<b>Title - Sujet</b> Whistler Building Envelope	
<b>Solicitation No. - N° de l'invitation</b> EZ899-210525/A	<b>Amendment No. - N° modif.</b> 002
<b>Client Reference No. - N° de référence du client</b>	<b>Date</b> 2020-08-05
<b>GETS Reference No. - N° de référence de SEAG</b> PW-\$PWY-019-8797	
<b>File No. - N° de dossier</b> PWY-0-43038 (019)	<b>CCC No./N° CCC - FMS No./N° VME</b>
<b>Solicitation Closes - L'invitation prend fin</b> <b>at - à 02:00 PM</b> <b>on - le 2020-08-14</b>	<b>Time Zone</b> <b>Fuseau horaire</b> Pacific Daylight Saving Time PDT
<b>F.O.B. - F.A.B.</b> <b>Plant-Usine:</b> <input type="checkbox"/> <b>Destination:</b> <input checked="" type="checkbox"/> <b>Other-Autre:</b> <input type="checkbox"/>	
<b>Address Enquiries to: - Adresser toutes questions à:</b> Ngan, Ken (PWY)	<b>Buyer Id - Id de l'acheteur</b> pwy019
<b>Telephone No. - N° de téléphone</b> (604) 671-0219 ( )	<b>FAX No. - N° de FAX</b> (604) 775-6633

This Solicitation Amendment 002 is raised to incorporate Addendum #01.

WHISTLER RESIDENCE - WALL CLADDING & ROOF  
REPLACEMENT

DRAWING:  
SECTION DETAIL - WINDOW HEAD/SILL REVISED

## SECTION DETAIL 1/A702 - WINDOW HEAD & SILL

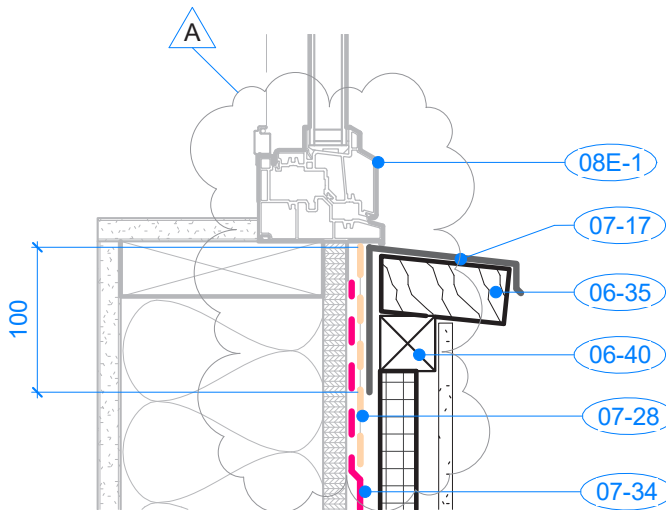
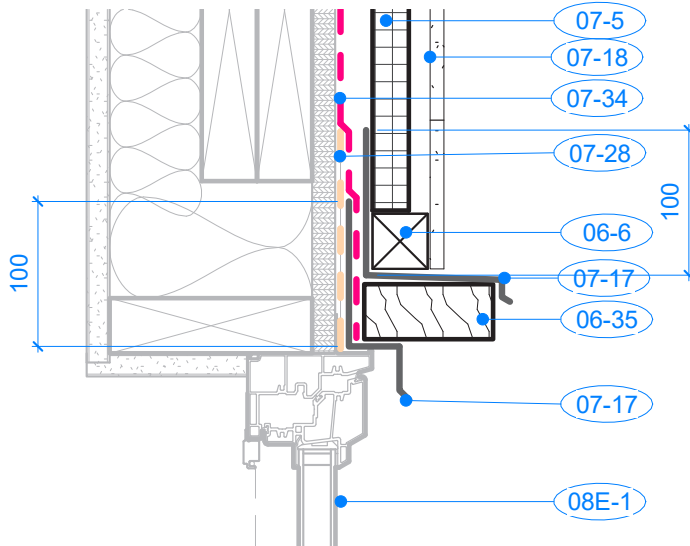
- .1 Reference: **DRAWINGS** Drawing A702 SECTION DETAILS
- a) **[REVISE]** Detail 1/A702: New air barrier membrane is to be slipped up under the existing building paper, as opposed to over as is currently indicated. Refer to revised detail 1/A702 on SK-1 attached.
